AGENDA
MANOR PLANNING AND ZONING COMMISSION
105 E. EGGLESTON ST.
MANOR, TEXAS 78653
MAY 13, 2015, 6:30 P.M.

Re: First Preliminary Plan Review for
Manor Commons SW
City of Manor, Texas

Re: First Final Plat Review for
Manor Commons SW
City of Manor, Texas

**RE: First Final Plat Review for Shadowglen Phase 2, Section 19B
City of Manor, Texas**

PRELIMINARY PLAN MANOR COMMONS SW

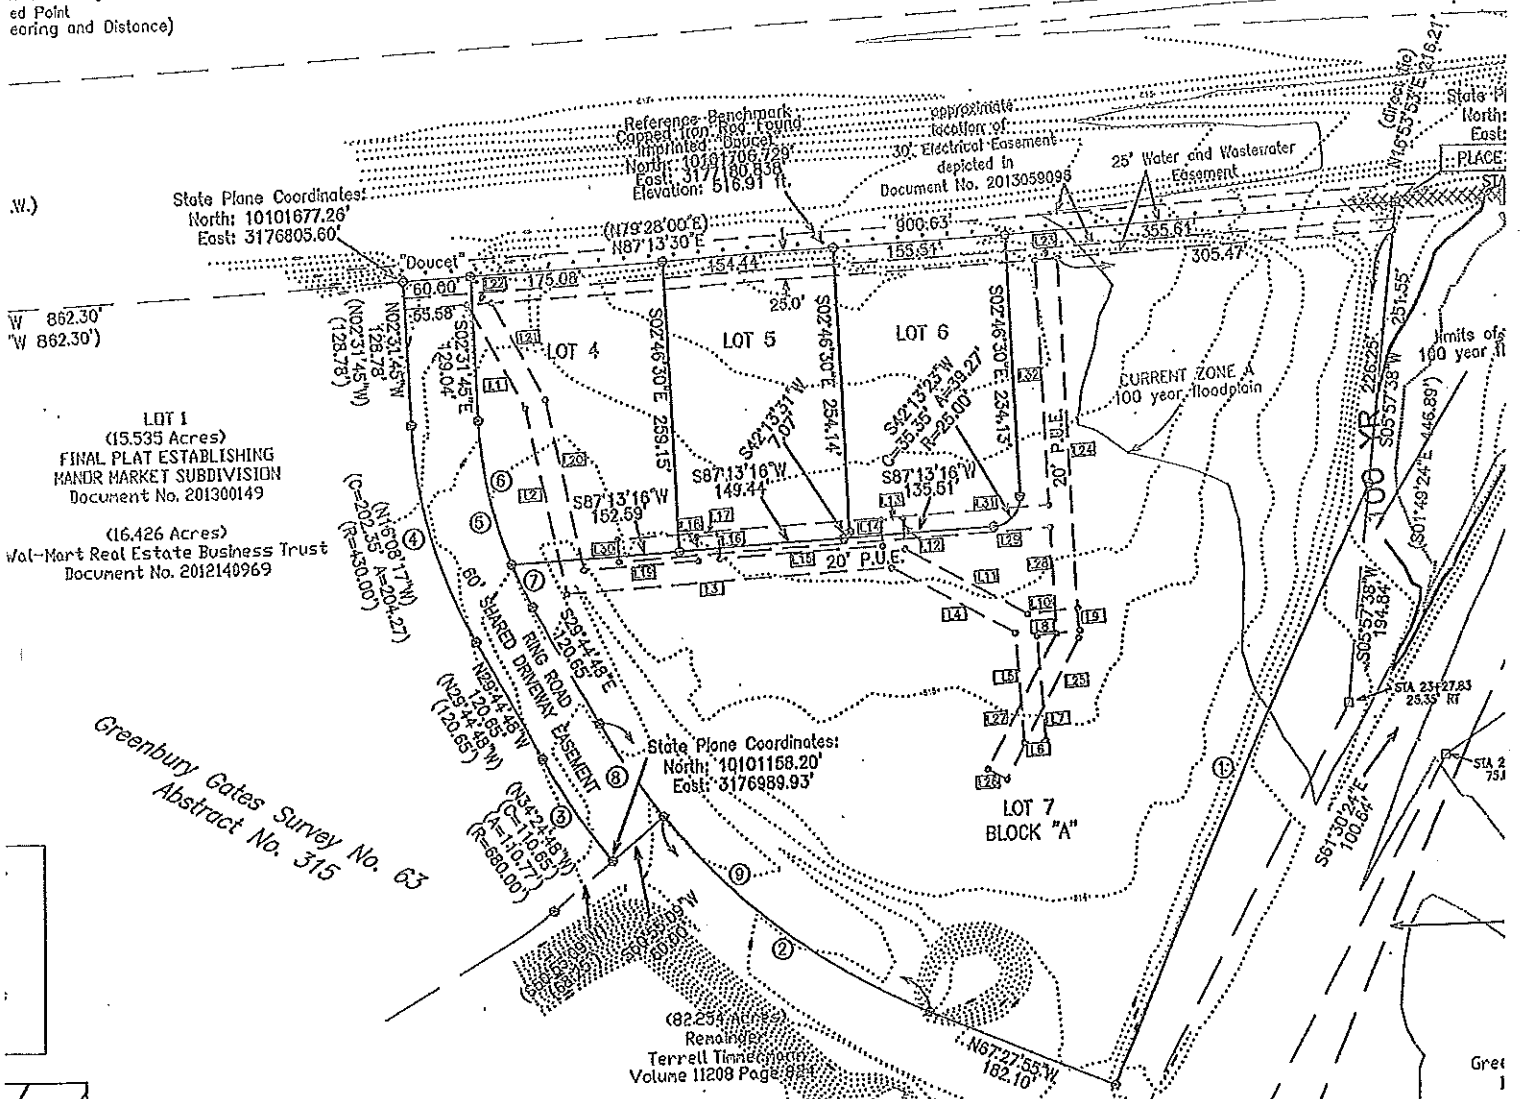
1. The location map is not to scale as required in Section 22(c)(1)(IV) of Subdivision Ordinance 263. A location map showing the relation of the subdivision to streets and other prominent features in all directions for a radius of at least one (1) mile using a scale of one (1) inch equals two thousand feet (1" = 2,000') must be shown on the Plan. The latest edition of the USGS 7.5 minute quadrangle map is recommended.

3. The centerline of the water course is not shown on the Plan as required in Section 22(c)(2)(iv) of Subdivision Ordinance 263. The centerline of water courses, creeks, existing drainage structures and other pertinent data must be shown on the Plan.

4. The dimensions for the existing boundary streets are not shown on the Plan as required in Section 22(c)(2)(viii) of Subdivision Ordinance 263. The location, dimensions, names and descriptions of all existing or recorded streets, alleys, reservations, railroads, easements or other public rights-of-way within the subdivision, intersecting or contiguous with its boundaries or forming such boundaries, as determined from existing deed and plan records must be shown on the Plan.

5. No utility demand data was provided as required in Section 22(c)(4)(i) of Subdivision Ordinance 263. Utility demand data, consistent with the proposed uses indicated on the Preliminary Plan, to determine the adequacy and the consistency of proposed utility improvements must be provided.

It has been brought to our attention during a feasibility analysis for a contemplated project on Lot 4, that an 8" line may not be sufficient to provide required fire flows. Verify fire flow capacities to the boundary of Lot 4. At a minimum, the water line must be extended to Lot 4 to provide service to the lot.

RESPONSE: The location map has been corrected.

RESPONSE: Centerline of water courses have been added to plan.

RESPONSE: The plat already gives right-of-way with on Hwy 290 and FM 793 is a variable width right-of-way, but the surveyor added a direct tie across the right-of way.

RESPONSE: Water and wastewater flow demands have been added to utility page. EPANET was used to calculate pressure and flow using peak demand and a 1500 gpm fire flow at the end of the 8 inch main extension that will be constructed as part of the Lot 4 site improvements. The residual pressure from the fire flow test provided was used as the pressure plane for the analysis. Tables have been added to the Utility Plan sheet.

FINAL PLAT ESTABLISHING MANOR COMMONS SW

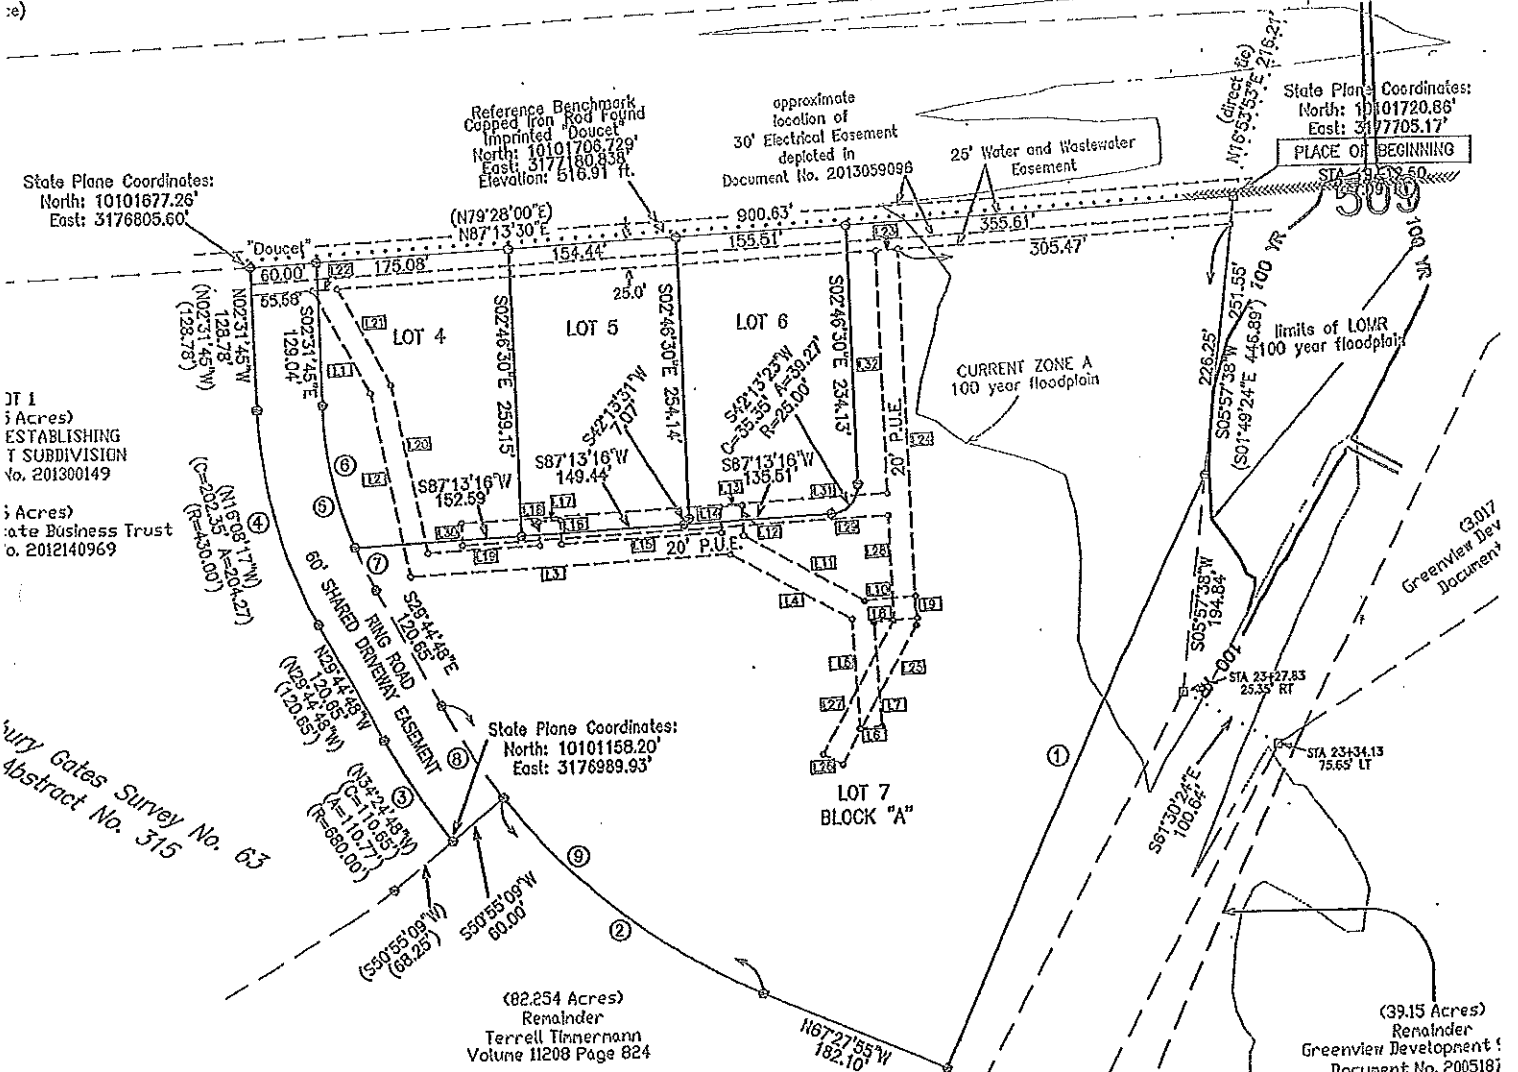
2. The location map is not to scale as required in Section 24(c)(1)(iii) of Subdivision Ordinance 263. A location map showing the relation of the subdivision to streets and other prominent features in all directions for a radius of at least one (1) mile using a scale of one (1) inch equals two thousand feet (1" = 2,000') must be shown on the Plan. The latest edition of the USGS 7.5 minute quadrangle map is recommended.

3. The dimensions for the existing boundary streets are not shown on the Plat as required in Section 24(c)(2)(iii) of Subdivision Ordinance 263. The location, dimensions, names and descriptions of all existing or recorded streets, alleys, reservations, railroads, easements or other public rights-of-way within the subdivision, intersecting or contiguous with its boundaries or forming such boundaries, as determined from existing deed and plan records must be shown on the Plan.

4. The locations of sidewalks are not shown on the plans as required in Section 24(c)(4)(viii) of Subdivision Ordinance 263. The proposed location of sidewalk for each street, to be shown as a dotted line inside the proposed right-of-way lines must be shown on the plat.

RESPONSE: Location map is now to scale.

RESPONSE: The plat already gives right-of-way with on Hwy 290 and FM 793 is a variable width right-of-way, but the surveyor added a direct tie across the right-of way.

RESPONSE: Locations of Sidewalks have been shown.
